Following this cover is a copy of our report 10CFR21-0132, Rev. 0, for a 10CFR21 reportable notification on a pressure regulator valve, Nordberg P/N 1776 506.

Report No. 10CFR21-0132

**10CFR21 REPORTING OF DEFECTS
AND NON-COMPLIANCE**COMPONENT: Pressure Regulator Valve
Nordberg P/N 1776 506

SYSTEM: Emergency Diesel Generator

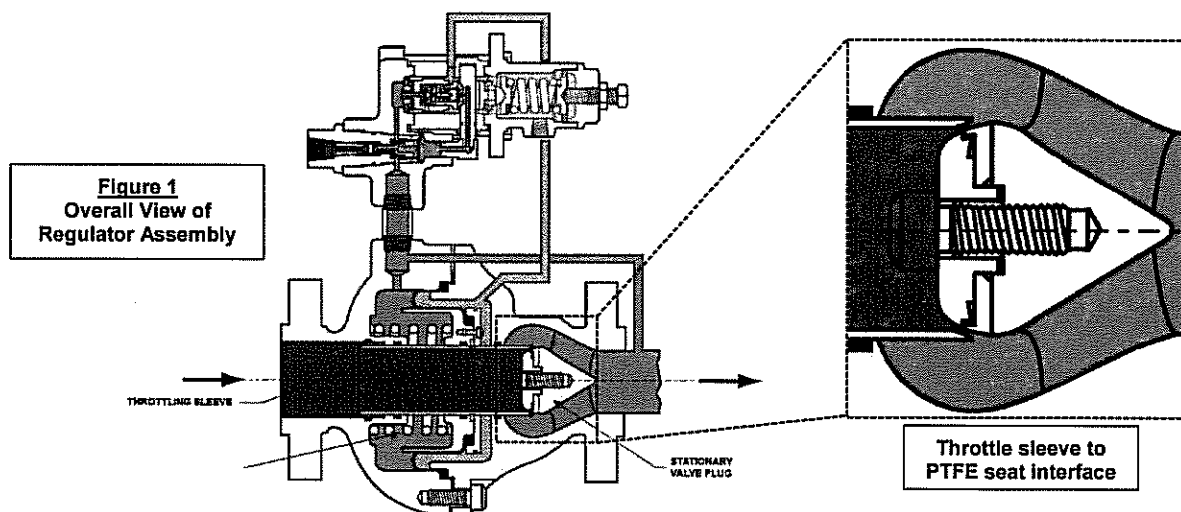
The pressure regulator valve is a Fisher brand assembly consisting of two main components: (1) the Type 310A main valve and (2) the Type 32A pilot. The flow of air travels through main valve. The pilot senses inlet and outlet pressures and provides feedback to open and close the main valve accordingly. In the main valve, air flows through a throttling sleeve and past a stationary valve plug. When air flow is no longer required, the throttling sleeve seats against the valve plug. The throttling sleeve is a metal tube with a tapered seat at one end. The valve plug contains a PTFE seat upon which the throttle sleeve seals. See Figure 1 below.

Photo 2: Seat removed, showing tear

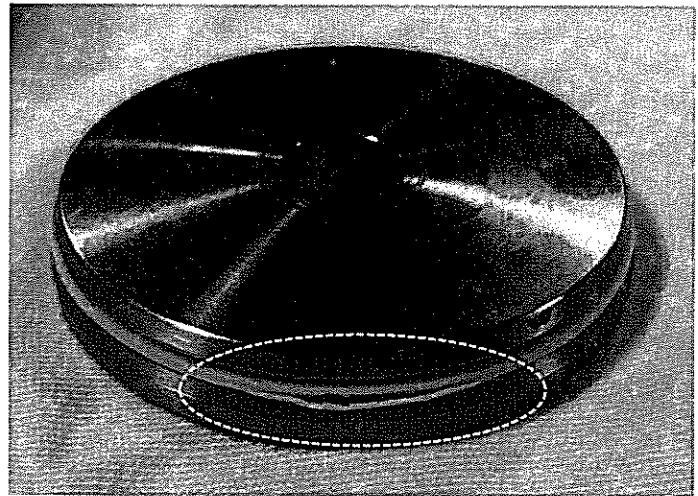
A pressure regulator valve installed on an emergency diesel generator at Brunswick Nuclear Plant (BNP), did not properly regulate starting air pressure and allowed equalization of inlet pressure to the outlet. Subsequent investigation by ESI revealed a raised edge on the metal seating surface of the valve that caused the PTFE seat to tear. Equalization of starting air pressure is undesirable since it may inhibit operation the downstream starting air solenoid valve, thus compromising ability of the emergency diesel generator to start and support safety-related loads.

It is recommended that these regulators have an inspection performed either on-site or at ESI. This requires disassembling (splitting) the main valve body halves and removing the throttling sleeve/diaphragm assembly. A "feel" check is to be performed at the transition of the valve seat taper to the end of the sleeve for a smooth, rounded transition. No raised edge or burr is allowed. When this inspection is performed, the PTFE seat should also be inspected for signs of fretting or tearing. Any signs of abnormality are cause for rejection and the component shall be reworked.
